PLANNING CLEARANCE

(Single Family Residential and Accessory Structures)
Grand Junction Department of Community Development

BLDG ADDRESS 419 1/2 Prospector Pt.
SUBDIVISION Ridges
FILING 6 BLK 30 LOT 4A
TAX SCHEDULE NO. 2945-174-34-004
OWNER Scott Vogtilla
ADDRESS 2631 Central Dr.
TELEPHONE 241-853

► APPROVAL FOR BUILDING PERMIT ◀
Ridges Architectural Control Committee (ACCO)

Prospector Point

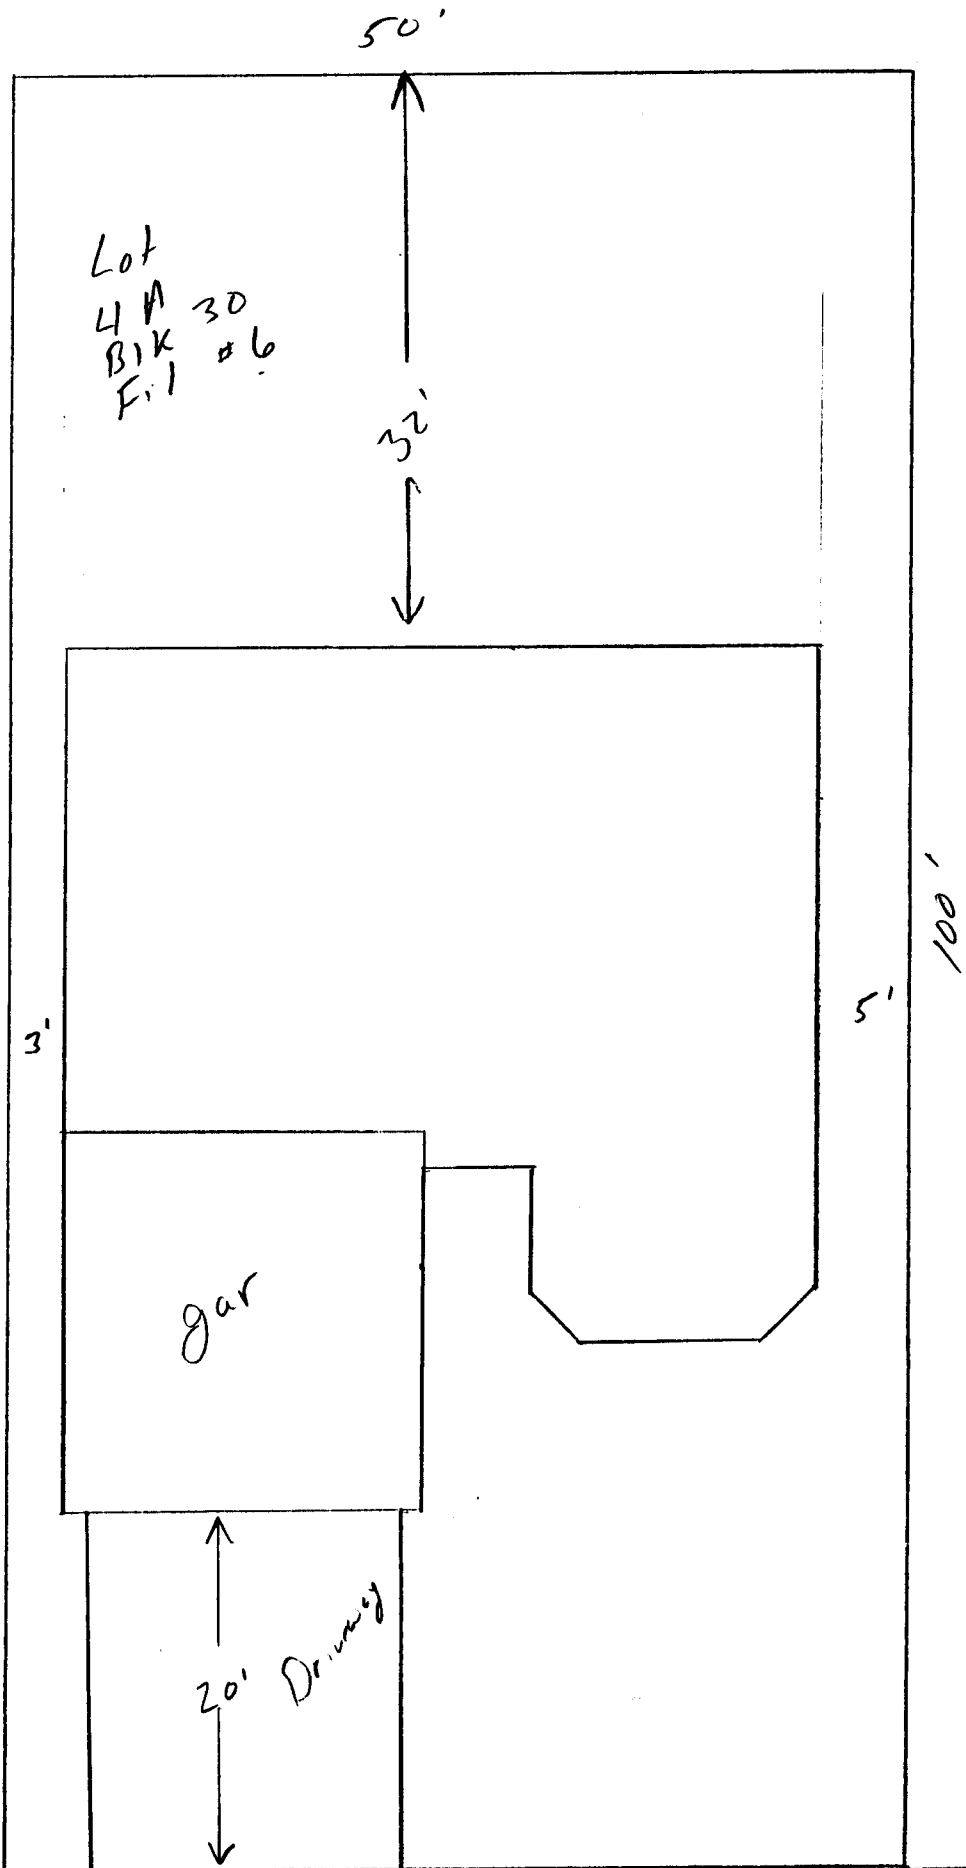
ACCEPTED RP 11/8/93
ANY CHANGE OF SETBACKS MUST BE
APPROVED BY THE CITY PLANNING
DEPT. IT IS THE APPLICANTS
RESPONSIBILITY TO PROPERLY
LOCATE AND IDENTIFY EASEMENTS
AND PROPERTY LINES.
